ATTACHMENT C – STORMWATER MANAGEMENT PLANS (MARTENS & ASSOCIATES, 2016)

SUBDIVISION, DRIVEWAY AND DRAINAGE WORKS

62 HILLSIDE ROAD, NEWPORT NSW
LOT 1 DP4 08800

ATTACHMENT D – REVISED SUBDIVISION PLAN (MARTENS & ASSOCIATES, P1203617PS03-A400)

DRAWING TITLE				
SUBDIVISION PLAN				
PROJECT NO.	PLANSET NO.	RELEASE NO.	DRAWING NO.	REVISION
P1203617	PS03	R02	PS03-A400	B

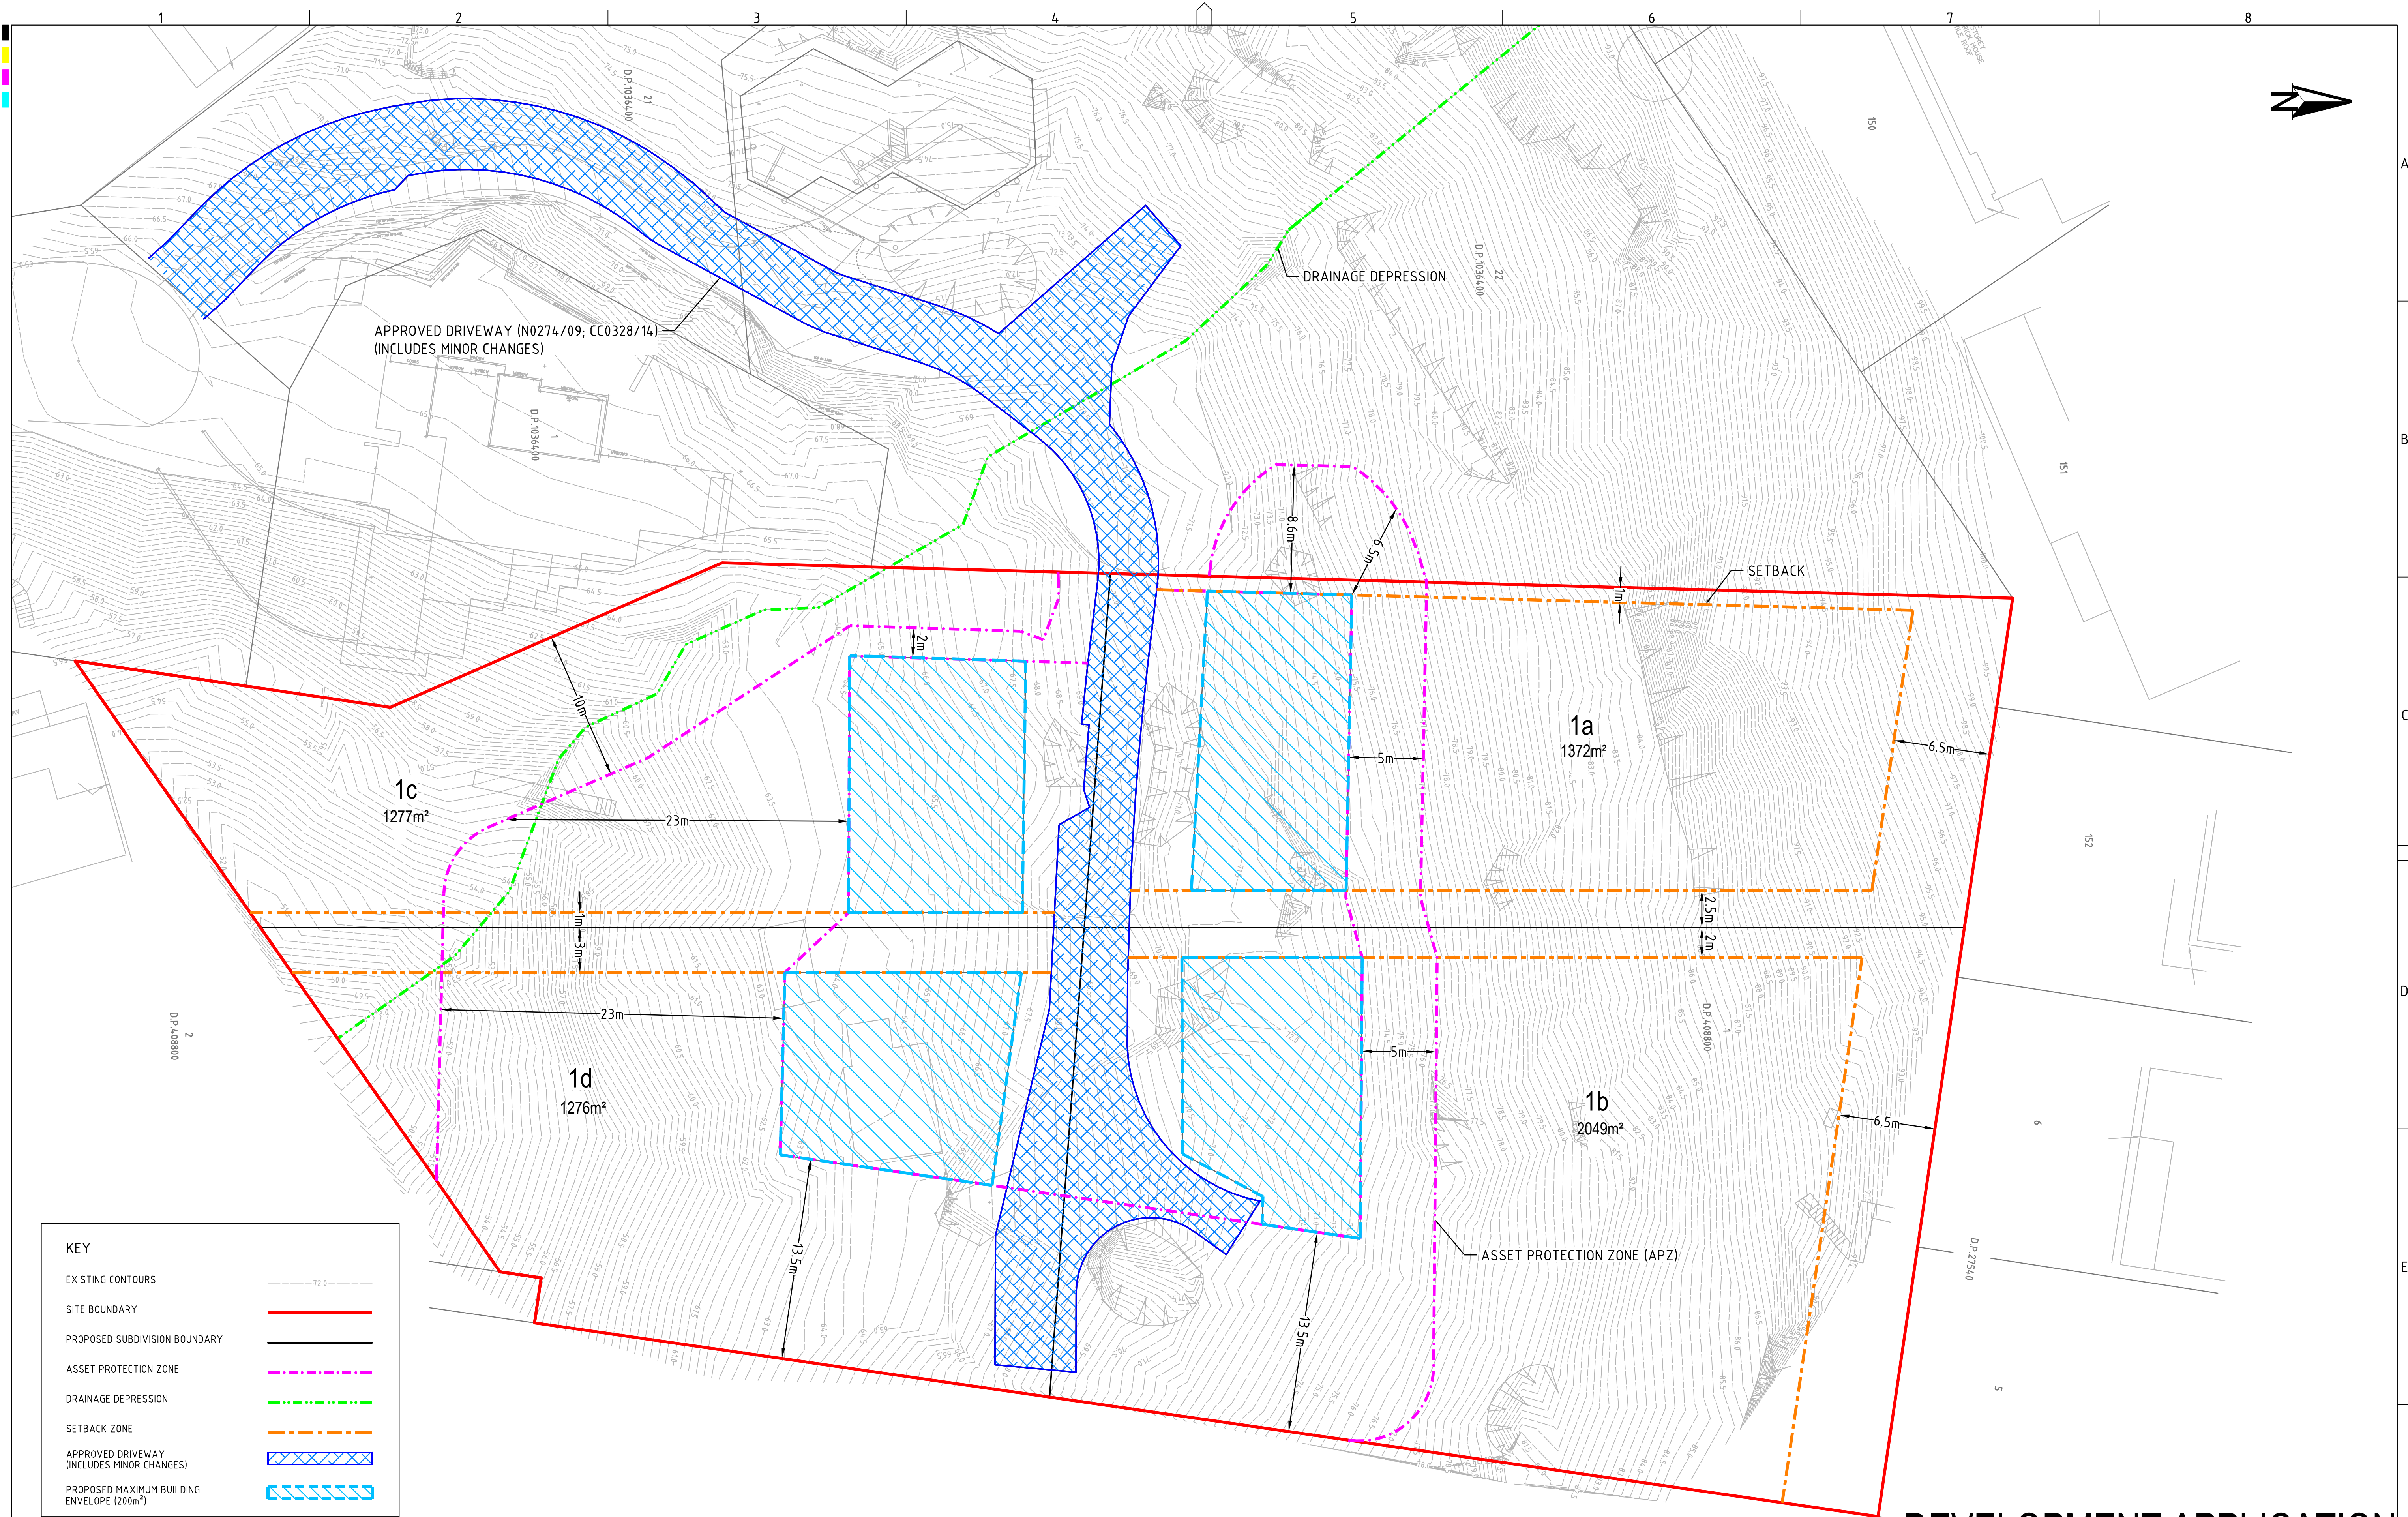
Thank you for speaking with me this afternoon. We have amended the Subdivision Plan (Martens & Associates, P1203617PS03-A400), removing the reference to 'indicative building envelope'. We have revised the legend key to read 'Proposed Maximum Building Envelope 200 m²', as since the application and supporting documentation provided to Council is still not yet determined/approved, we are not able to specify that the building envelopes are 'set' (i.e. the application is still in a 'proposal' stage). That will be assumed when plans are stamped by Council, after which time an application to change Council consent would be required to alter the building footprint.

Yes that plan is satisfactory with the building envelopes.
